ADDENDUM #1 – SEPTEMBER 9, 2021

RE: DOUGLAS COUNTY
SALMON HARBOR MARINA OFFICE ADDITION
Project #19.64

FROM: HGE ARCHITECTS, Inc.
333 South 4th Street
Coos Bay, Oregon 97420
541-269-1166

1 ROOF DETAIL
SCALE: 1 1/2" = 1'-0"

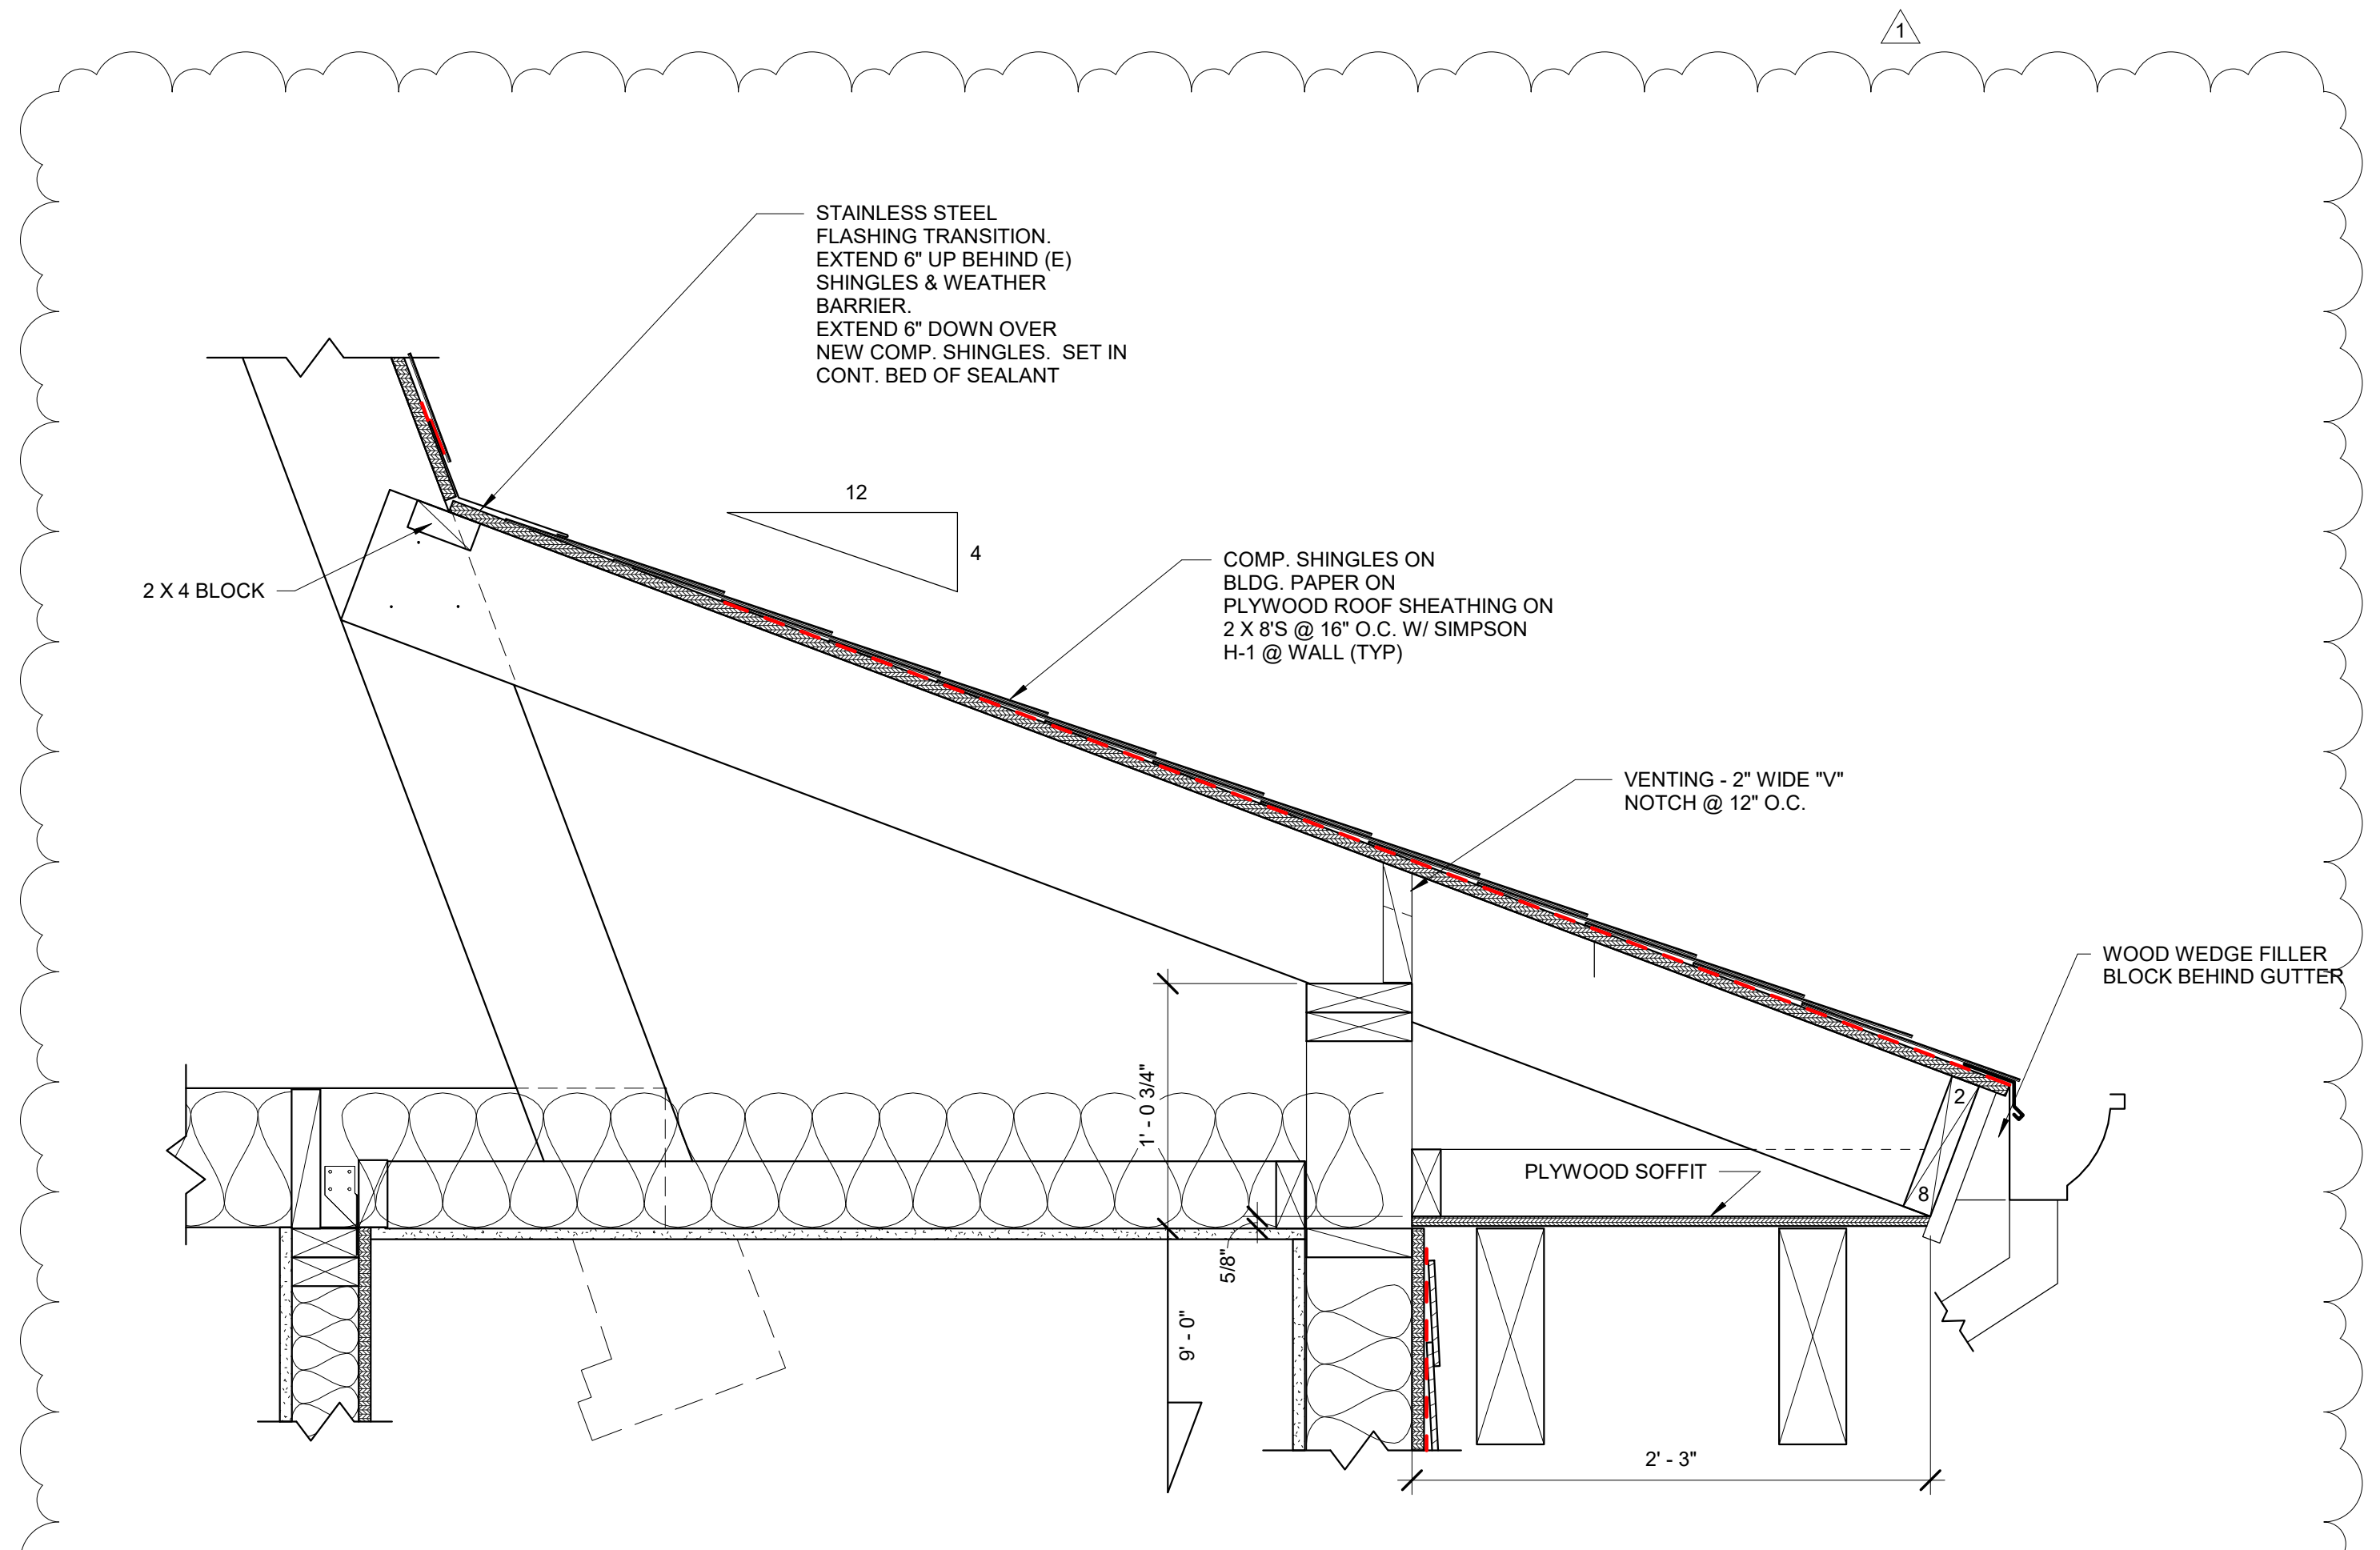
3. **Sheet A5.1, Building Details: See attached REVISED Sheet A5.1.**
 - a. Drawing 1/A5.1 Roof Detail – This is a new detail showing the flat soffit at the cut off piling
